**CM MUNCASTER MILL, LLC
CONDITIONAL USE NO. CU202407 AND
PRELIMINARY FOREST CONSERVATION PLAN NO.
F20230500**

Request for Conditional Use approval to construct a (Design for Life) Townhouse Living community in the R-200 Zone.

No. CU202407

MCPB
Item No. [X]
December 21, 2023

Figure 5: Southwest Corner of Site

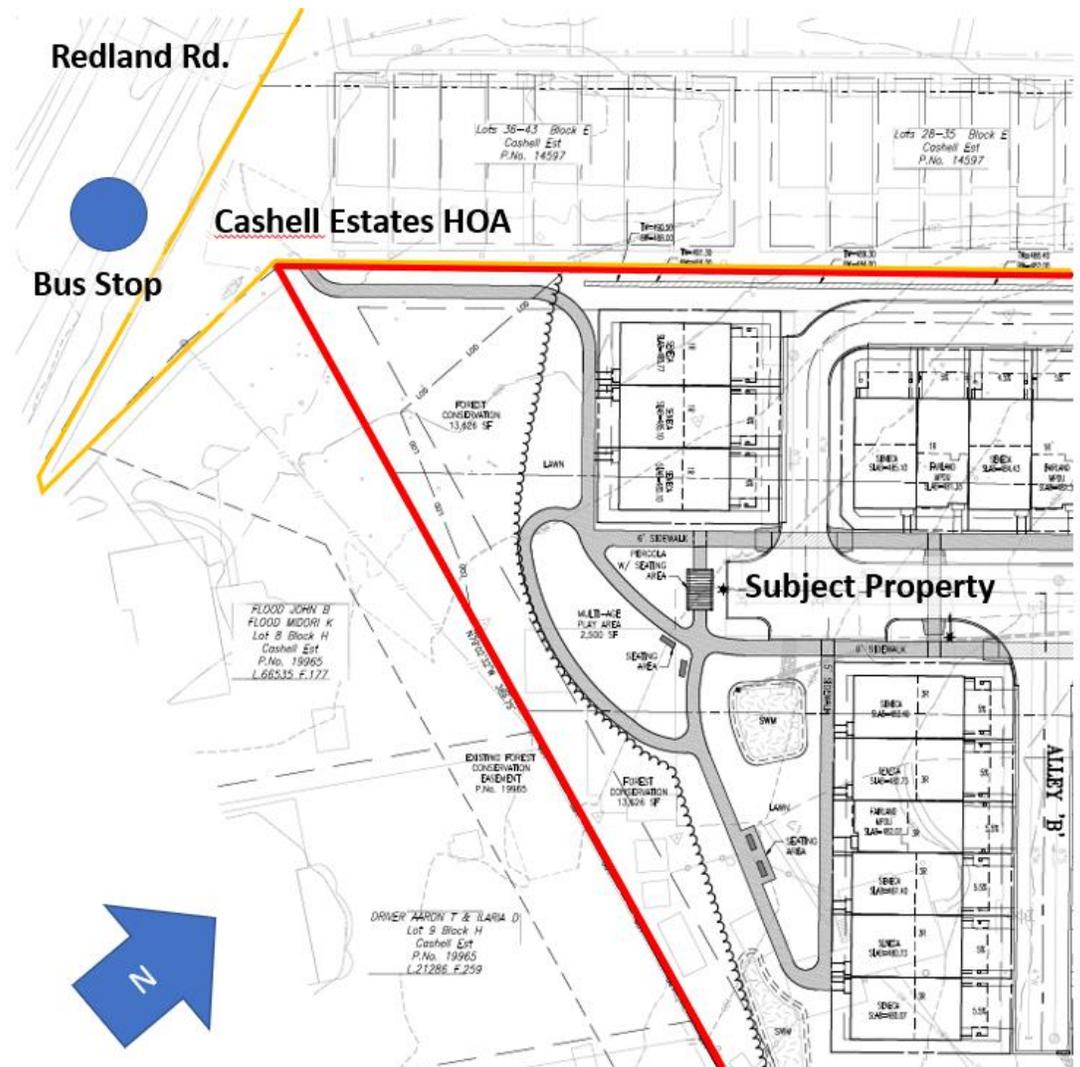
An extension of this trail is proposed into the western corner of the site closest to Redland Road (Figure 5), with details to be determined as part of the Preliminary Plan Process. This is to accommodate potential future connectivity to Redland Road, with a public access easement to be provided as part of the Preliminary Plan. A small corner of communally owned property by the neighboring Cashell Estates HOA (outlined in lighter shaded line) separates the Subject Property (outlined in darker shaded line) from Redland Road. Conversations are ongoing with the HOA to explore options for connectivity across this portion of property, to be determined as part of the Preliminary Plan process. If found to be agreeable by the HOA, the Applicant will provide the paved connection. This connection is important to pursue for the community to

access Redland Road, in particular the nearby bus stop which serves the Ride On 53 and 57 bus lines, both providing access to Shady Grove Metro and points beyond. Without this link, riders from the Application must walk an additional 1/3 mile, or 6 minutes, to access the stop, a significant hurdle for all users, particularly those with mobility impairments. Bus riders from the community may instead be forced to rely on the 53 line only, which provides a stop along Muncaster Mill Road fronting the Subject Property, which only operates peak weekday hours, with a limited frequency of every 50 minutes, or for individuals with mobility challenges, rely on more expensive and inconvenient dial-a-ride services. Staff will continue to work with the Applicant and Cashell Estates HOA to explore options to provide this connection.

- d. As part of the Preliminary Plan, all proposed intersections must provide crosswalks and ramps across all four legs of the intersection.
 - e. As part of the Preliminary Plan process, the Applicant will continue to explore options with Planning Staff to extend a paved trail connection to Redland Road

Figure 8: Proposed Variance Tree Impacts

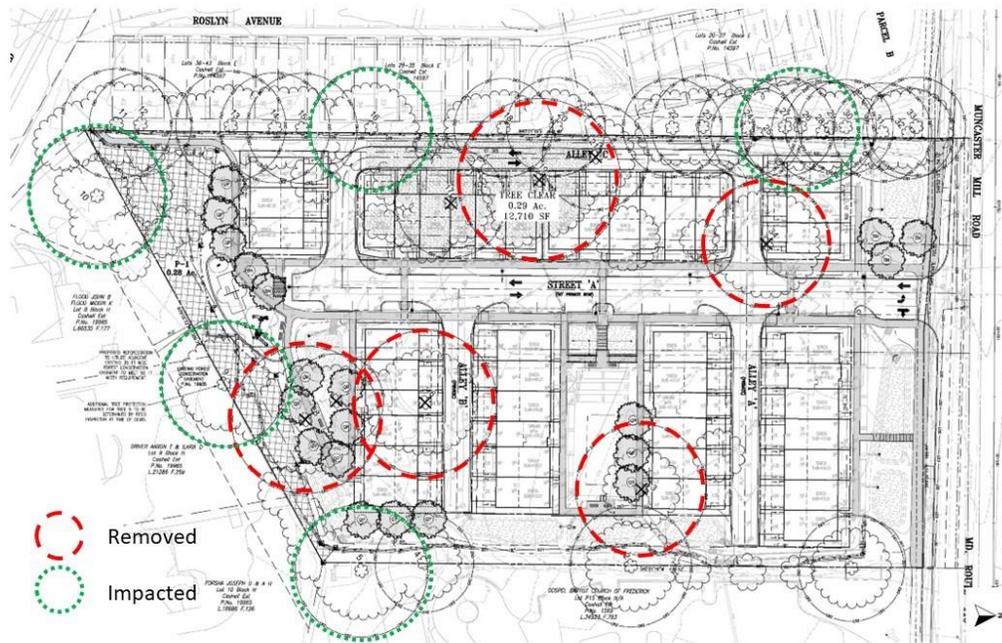
Along the western edge of the site, a number a of trees are impacted by Alley 'C'. This alley is needed to facilitate rear loading units and to allow the proposed townhomes to front on Street 'A'. These streets and alleys must be at least 20 feet wide to avoid fire access related height restriction for the proposed townhouses and to allow fire truck access to all portions of the site. This requirement further limits flexibility for the design. Along with the alley and road restrictions, each dwelling unit must have two parking spaces for residents. This requirement means the driveways must be at least 20 feet long to accommodate a parked vehicle in addition to the garage space.

Staff has reviewed this Application and based on the existing conditions on the Subject Property and has determined that there is an unwarranted hardship.

Staff recommends that mitigation for the loss of the specimen trees be provided onsite. Mitigation should be at a rate that approximates the form and function of the tree removed. Staff recommends that replacement occur at a ratio of approximately 1-inch caliper for every 4-inch DBH removed ($268 \times .25 = 67$). Mitigation for the removal of the five (5) trees must be provided in the form of native canopy trees with a minimum size of three (3) inches in diameter at breast height. While these trees will not be as large as the tree lost, they will provide some immediate canopy and will help augment the functions lost.

1. The Applicant must plant the variance tree mitigation plantings on the Subject Property with a minimum size of 3 caliper inches totaling 67 caliper inches. Planting locations to be shown on the Final Forest Conservation Plan (“FFCP”). The Applicant must submit a Final Forest Conservation Plan (“FFCP”) for review and approval before obtaining a Sediment and Erosion Control Permit from the Montgomery County Department of Permitting Services for this Subject Property.

FIRE DEPARTMENT ACCESS PLAN
MUNCASTER MILL PROPERTY
 4th ELECTION DISTRICT
 MONTGOMERY COUNTY, MARYLAND

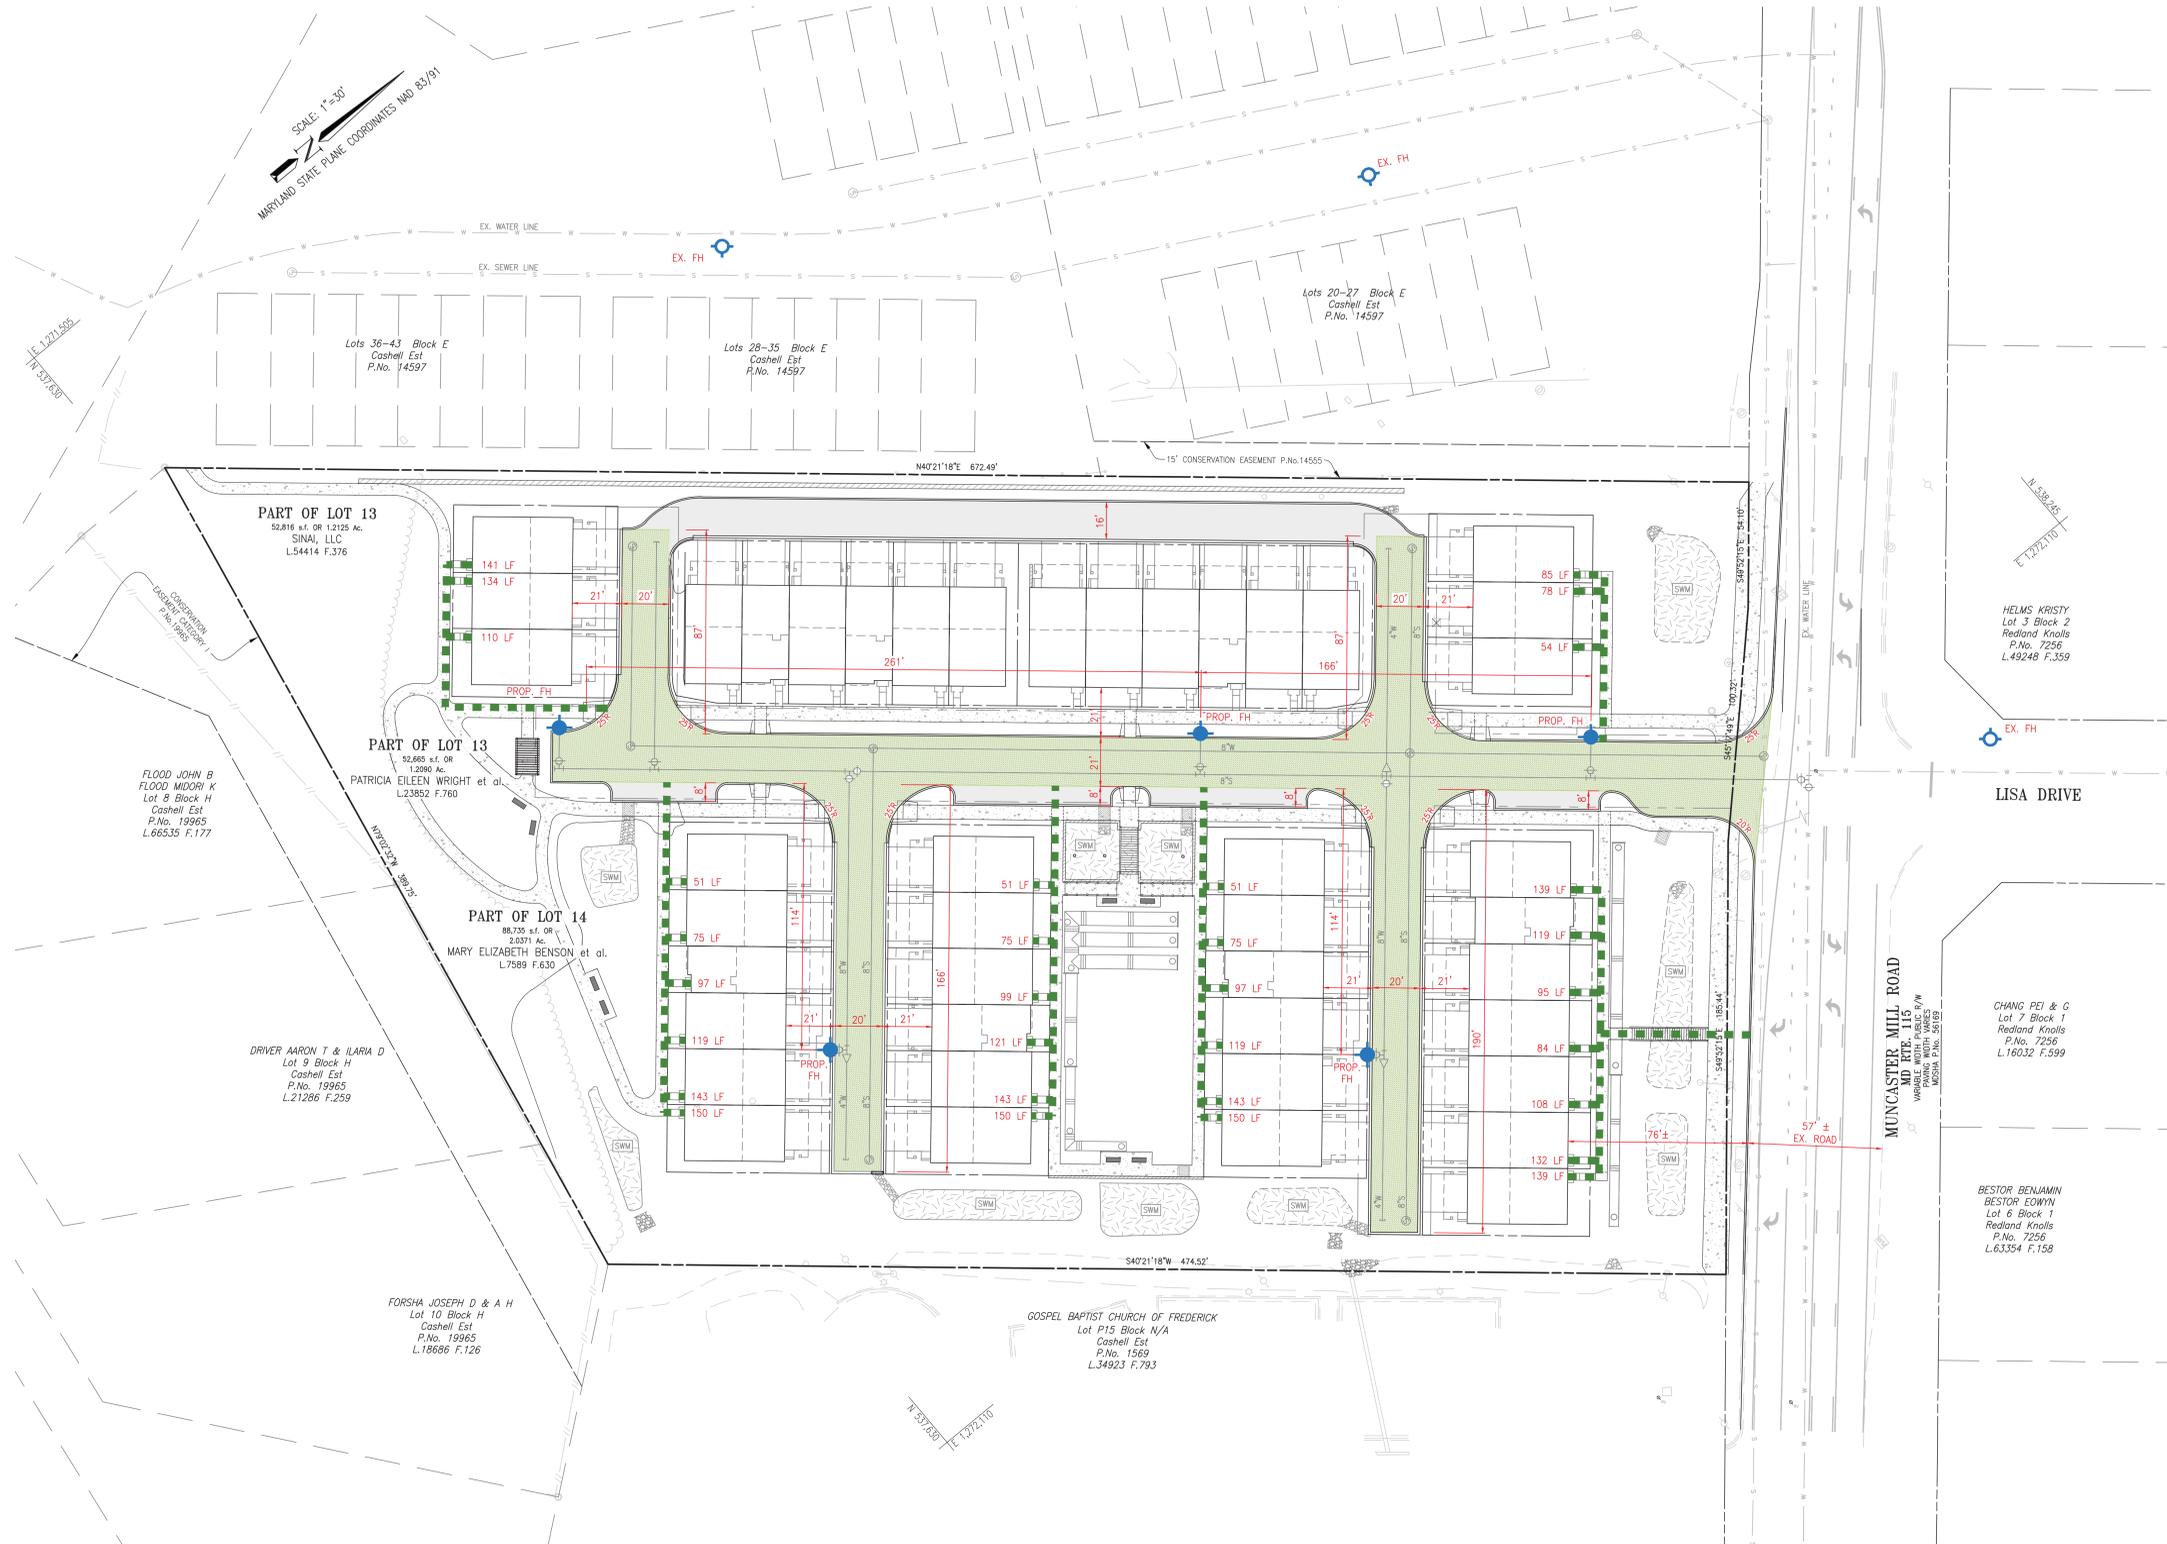
We are requesting the allowance for a performance based designed alternative to the requirements in Section 18.2.3.2.3.2 which state that units “having window sills greater than 27 feet from grade on the same side of the structure as fire department apparatus access, must provide access to the occupied interior through a main, side-hinged door, via a clear and unobstructed walkable grade, within 50 feet of fire department apparatus access, unless otherwise approved by the AHJ.” For this site, many of the units are perpendicular to the main private road at the site, extending the distance beyond 50 feet. A modification is needed to eliminate the height restriction. The proposed alternative based on meeting the performance-based design requirements will be as outlined below:

FIRE CODE ENFORCEMENT
 Fire Department Access Review
 Review based only upon information contained on this plan. Does not cover unsatisfactory layout resulting from omissions, errors or failure to clearly indicate conditions on this plan. Correction of such unsatisfactory layout to afford required access will be required if found upon inspection after installation.
 BY: SAC PM: 43 DATE: 12/1/2023
